PART 21 - AN OPERATING MECHANISM FRONT COVER FAILED DURING LICENSEE RECEIPT INSPECTION

Re: PART 21 Notification – K-Line Circuit Breaker Operating Mechanism

Subject: 10CFR Part 21 Notification of Deviation re. K-Line Circuit Breaker Operating Mechanism Covers

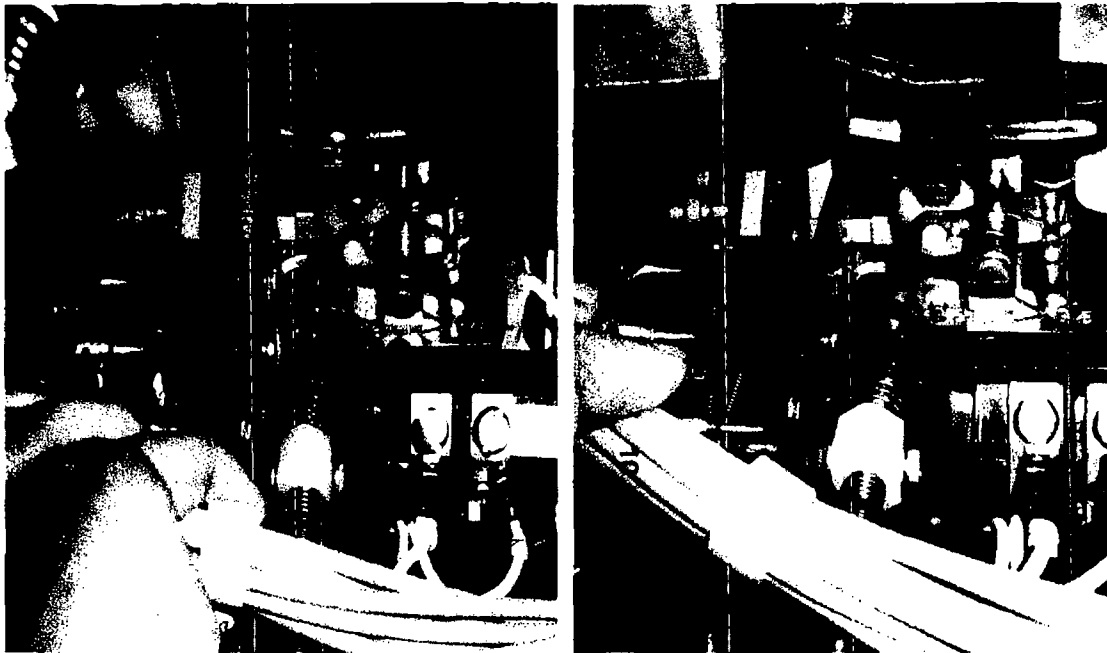
4. Nature of the deviation: One of thirty breakers provided to Seabrook failed to close during receiving inspection. This issue was communicated to ABB 9/14/2012. The subject operating mechanism cover was returned to ABB for inspection and root cause analysis on 9/18/2012. The root cause for the cover hole locations being out of position is corrective maintenance required of the six-part progressive die tooling used in the manufacturing process. Extent of condition performed by ABB indicated all P/N 707939A00 and 707939B00 in inventory had control device mounting hole locations out of position.

Misaligned plunger to secondary close latch.

Correctly aligned plunger to close latch.

- a. Removed all P/N 707939A00 and 707939B00 covers from inventory. (Action complete)
- b. Notified Accutrex Products, Inc. of the issue and completed process audit of tooling and manufacture of P/N 707939A00 and 707939B00 covers. This review was supported by ABB Supply Chain Manager, QA Engineer and Fabrication Manager. (Action complete)
- c. ABB approved corrective maintenance repairs to five of six pieces of tooling used to manufacture P/N 707939A00 and 707939B00 covers. All maintenance and repairs to these tools are completed. One of six tools was removed from use. Secondary operations were established to drill control device mounting holes after operating mechanism covers manufactured with first piece run expected to be completed 11/15/2012.
- d. Revised P/N 707939A00 and 707939B00 Critical Characteristics to include control device mounting hole locations. (Action complete)
